WAYNE DISPOSAL, INC.

RE: Wayne Disposal Site No. 2, Master Cell VI-F & G TSCA Approval Amendment
Response to EPA's comments (October 1, 2012)

Exhibit A. Plasticity Chart for USCS

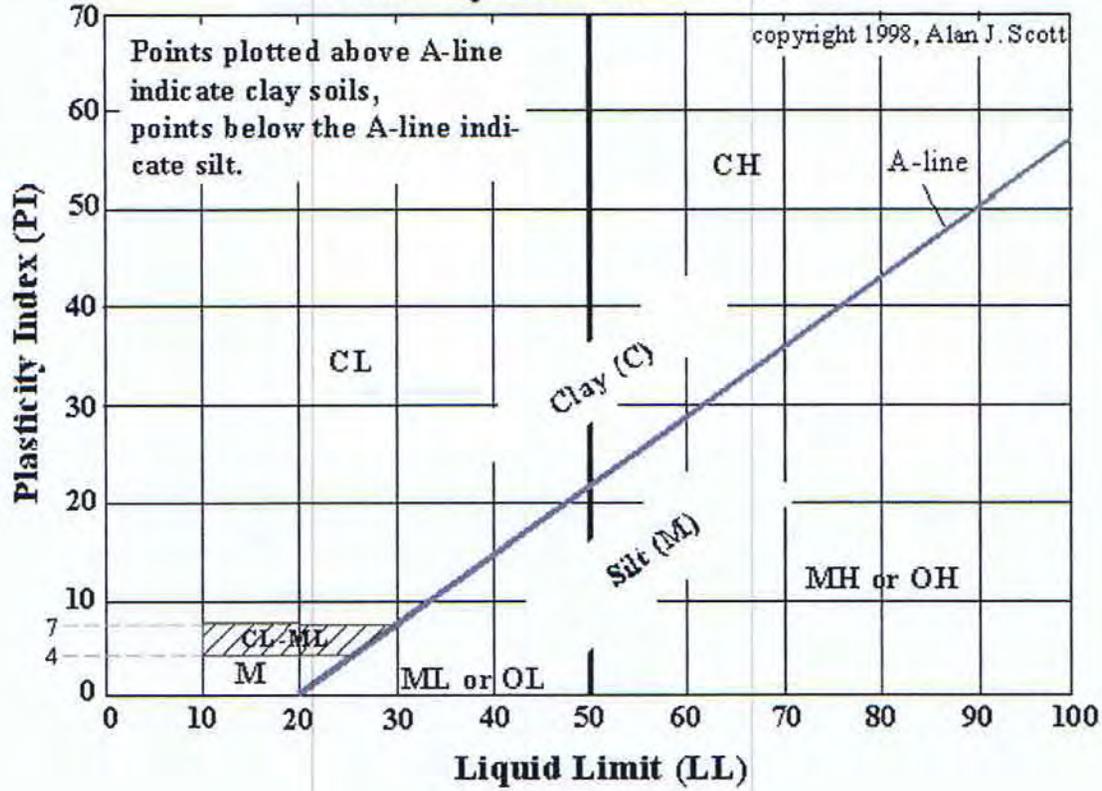
1. Section 761.75(b)(1) of 40 CFR specifies that, where the landfill site is not located in thick, relatively impermeable formations such as large-area clay pans, a Toxic Substances Control Act (TSCA) landfill should be constructed in soil that has a high clay and silt content with the following parameters:
 - a. *In-place soil thickness 4 feet or compacted soil liner thickness, 3 feet*
 - b. *>30% soil passing no. 200 sieve;*
 - c. *permeability $\leq 10^{-7}$ centimeters per second (cm/sec);*
 - d. *liquid limit >30; and*
 - e. *plasticity index > 15.*

The Approval Application does not clearly demonstrate that the soil underlying the proposed landfill expansion meets all of the foregoing parameters. Revise the Approval Application to clearly show that the landfill will be constructed in soil that meets the >30% passing No. 200 sieve standard, has a liquid limit >30; and a plasticity index >15.

As shown in Appendix C of Volume IV-Hydrogeologic Investigation Report and on Figures 12 through 18 in Volume IV of the Application, the 10 feet of native clay (Glacial Clay) generally consists of soils classified as CL based on the Unified Soil Classification System (USCS) with a permeability of 1.0×10^{-7} cm/s or less. Additional laboratory test results are shown on the Summary of Laboratory Test Data in Appendix C of Volume IV of the Application.

Exhibit C. Revised Groundwater Attachment H and Well Location Map

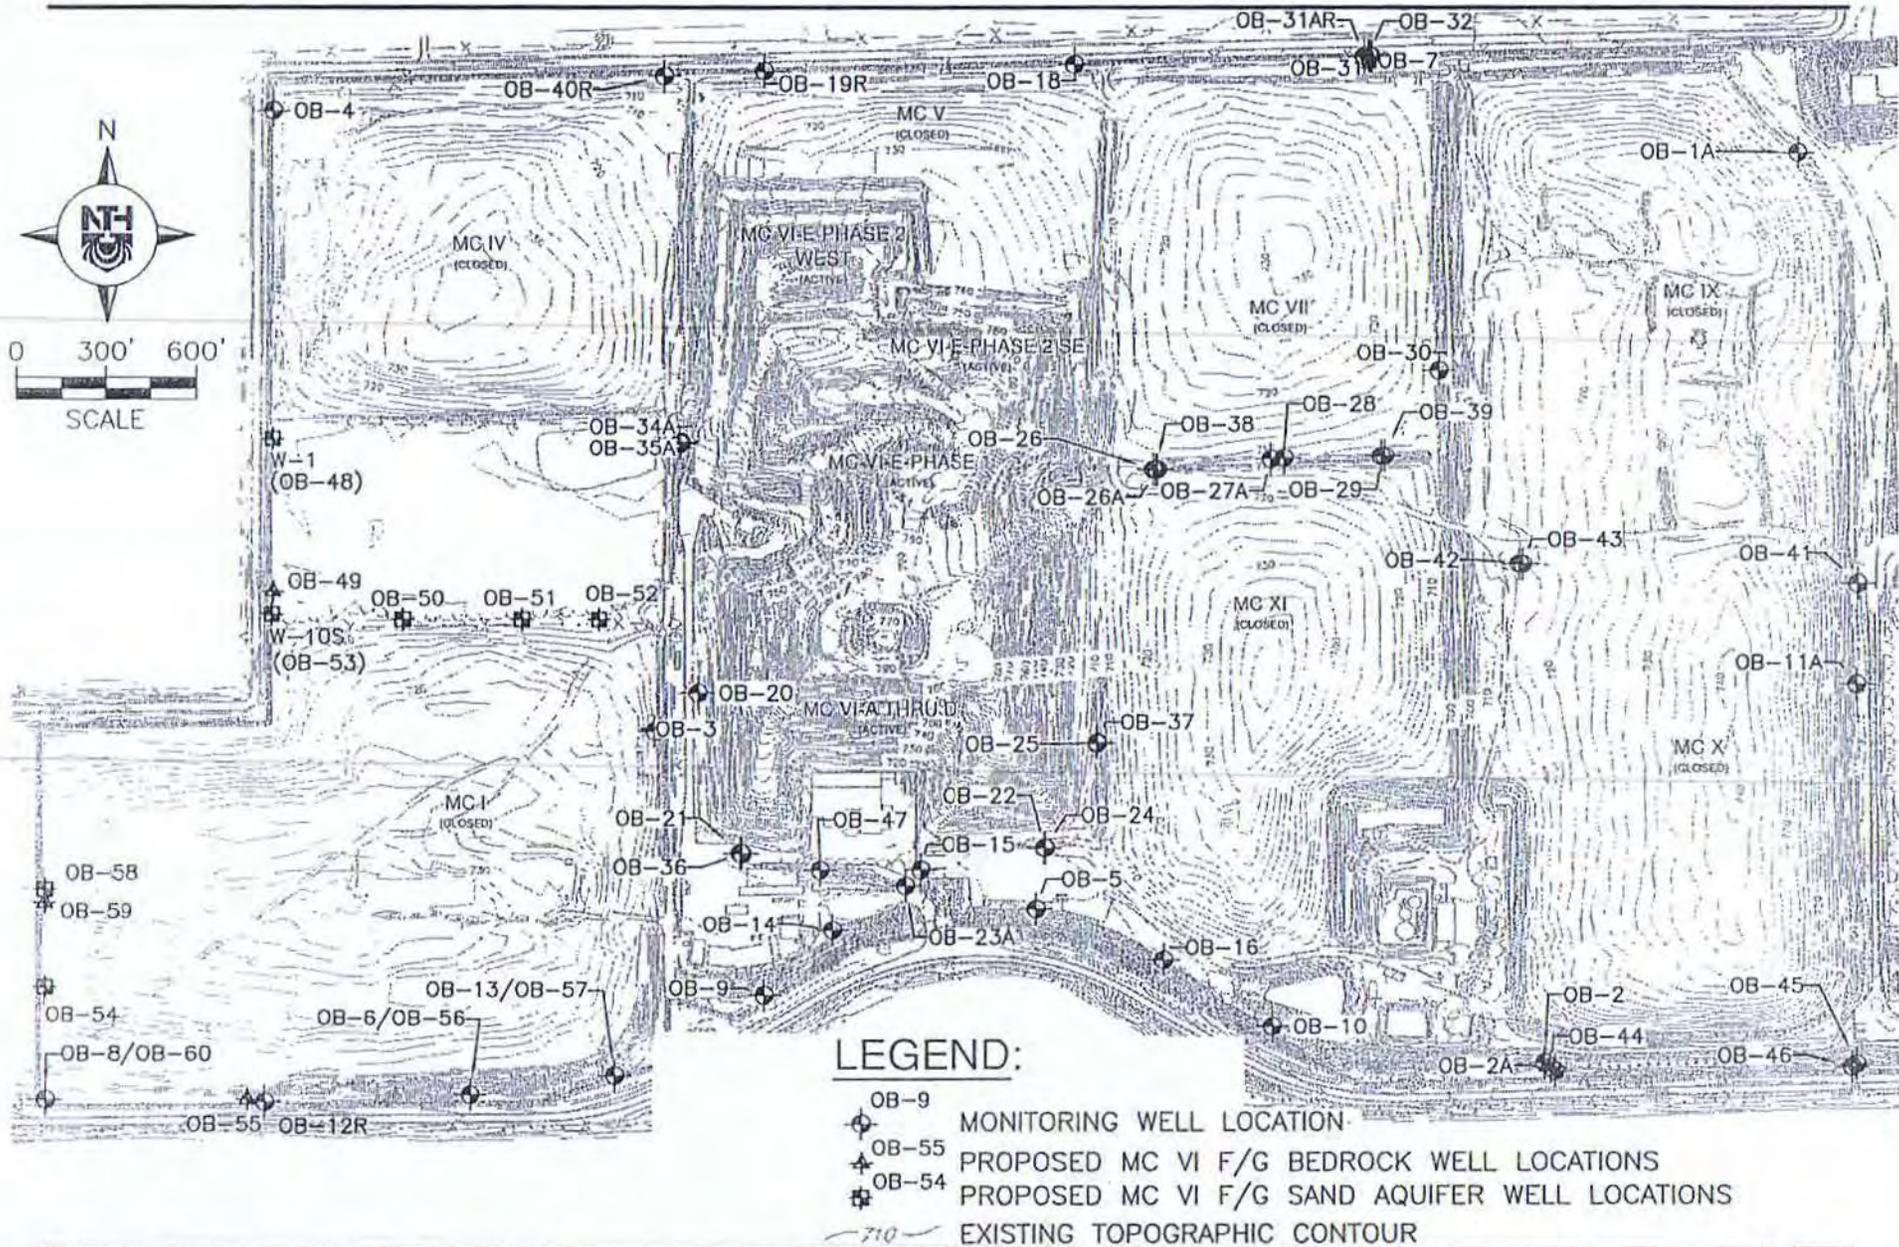
9. *The Approval Application does not include a figure or cross-sections that clearly show how the current monitoring well network of OB-21, OB-23R, OB-24, OB 34R and OB-40R comprises at least three wells equally spaced along a line through the center of the disposal area and how the monitoring wells extend from highest to lowest water table elevation as required by 40 CFR § 761.75(b)(6)(ii)(A). Revise the Approval Application to demonstrate how the current, as well as any future, PCB-specific monitoring well network comprises at least three wells equally spaced along a line through center of the disposal area and how the monitoring well network is capable of monitoring from the from highest to lowest water table elevation.*

12. *The Groundwater Sampling and Analysis Plan included as Section 27 in Volume II of the Approval Application does not specify a sampling frequency for monitoring wells. Revise the Approval Application to include a minimum sampling frequency for monitoring wells sampled to assess point*

WDI Response: In addition to the current wells listed above, WDI will designate new wells per the revised Groundwater Sampling and Analysis Plan in WDI's current Operating License. The program is phased to correspond to the construction sequence. Attachment H of Section 27 of the application has been updated to include the additional wells that will be monitored for PCBs. This revised Attachment and a map showing the proposed well locations are included with this response as Exhibit C. The placement of the wells including the depths, screened intervals, location of well pairs and spacing between wells has been developed, as described in the application, to be consistent with the current monitoring system and the hydrogeological conditions identified in the study included as Volume IV of the Application.

WDI Response: Review of the Application and WDI's Michigan Part 111 (RCRA) Operating License revealed that both are indeed devoid of any explicit specification of sampling frequency, except for a reference to quarterly groundwater reports. The easiest remedy for this oversight is to modify Attachment H of Section 27 in the Application (also Attachment H of Attachment 9 in the Operating License) to reflect quarterly sampling. An amended Attachment H is included with this response (Exhibit C) and will also be sent to MDEQ as a replacement page in the Operating License.

Exhibit D. Vibratory Smooth Drum Roller

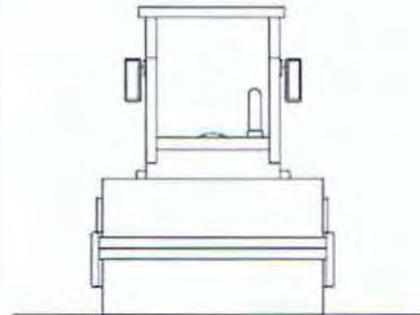
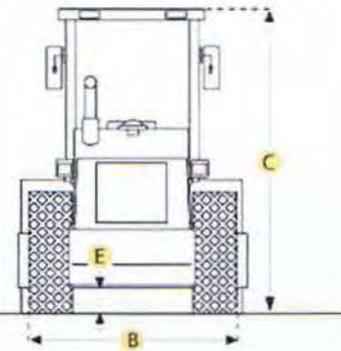
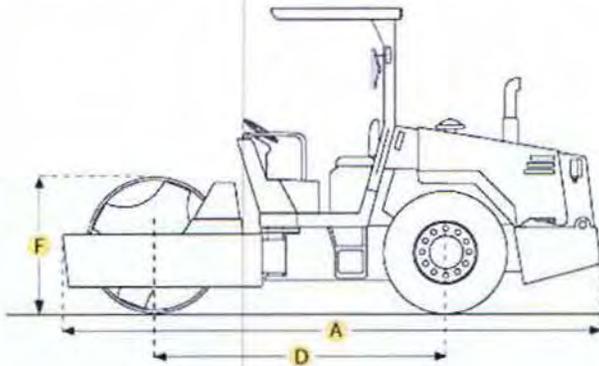
21. *The Approval Application does not include a specification that the landfill surface material must be dry enough to support the cap profile [i.e., support 10 pounds per square inch (psi)]. Revise the Approval Application to specify that the landfill surface material must be dry enough to support the cap profile (i.e., support 10 psi).*

WDI Response: Section 8.0 in Appendix K of Volume III of the Application, specifies the CQA requirements during final cover construction of MC VI-F&G. Included in this specification is a requirement to "smooth drum roll the leveling layer... to identify any areas of excessive deflection..." As shown in the attached equipment specification sheet (Exhibit D), typical equipment used to smooth drum roll the leveling layer, prior to the composite cap final cover construction, is in excess of 10 pounds per square inch (psi). Any areas exhibiting excessive deflection, due to moisture or other factors, are subject to corrective action under the CQA plan.
